Project	IEEE 802.16 Broadband Wireless Access Working Group < http://ieee802.org/16 >	
Title	Figures for the Comment Resolution	
Date Submitted	2002-10-28	
Source(s)	Itzik Kitroser Runcom Technologies Ltd. Homa 2 Rishon Lezion 75655 Israel	Voice: +972-3-9528440 /107 Fax: +972-3-9528805 itzikk@runcom.co.il
Re:	IEEE LMSC Sponsor Ballot recirculation of P802.16a/D5	
Abstract	Proposed material referenced by submitted comments.	
Purpose	Adoption	
Notice	This document has been prepared to assist IEEE 802.16. It is offered as a basis for discussion and is not binding on the contributing individual(s) or organization(s). The material in this document is subject to change in form and content after further study. The contributor(s) reserve(s) the right to add, amend or withdraw material contained herein.	
Release	The contributor grants a free, irrevocable license to the IEEE to incorporate material contained in this contribution, and any modifications thereof, in the creation of an IEEE Standards publication; to copyright in the IEEE's name any IEEE Standards publication even though it may include portions of this contribution; and at the IEEE's sole discretion to permit others to reproduce

Figure 55a-Periodic ranging - BS (CDMA Ranging case)

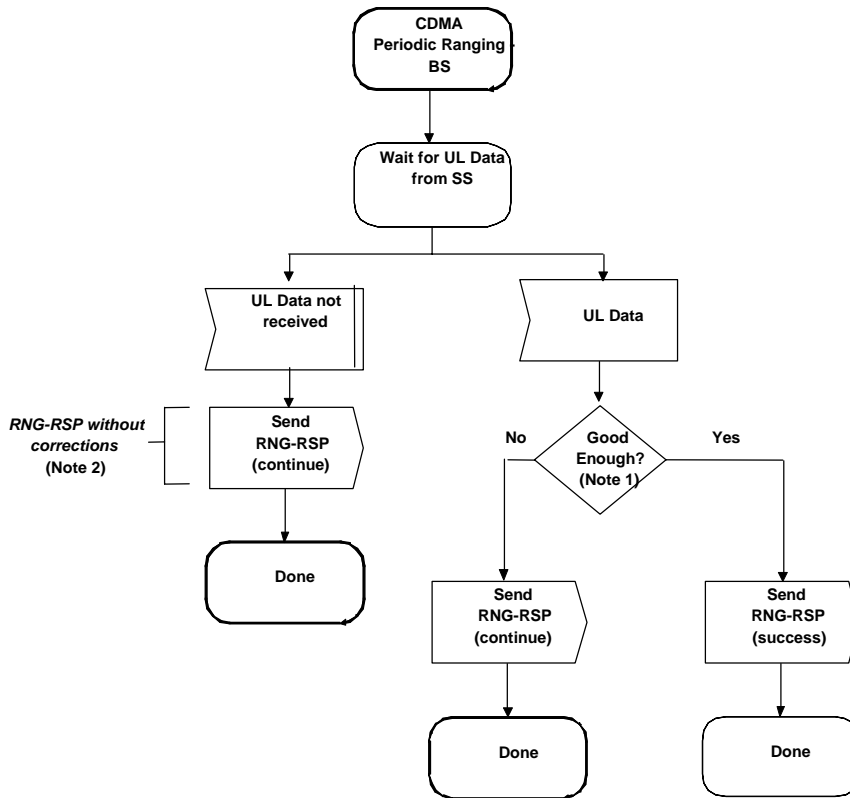
Add the following figures for the CDMA Ranging case (6.2.10.2).

NOTE 1—Means ranging is within the tolerable limits of the BS.

NOTE 2—In this case, the RNG-RSP message is sent in order to initiate the SS to send ranging code.
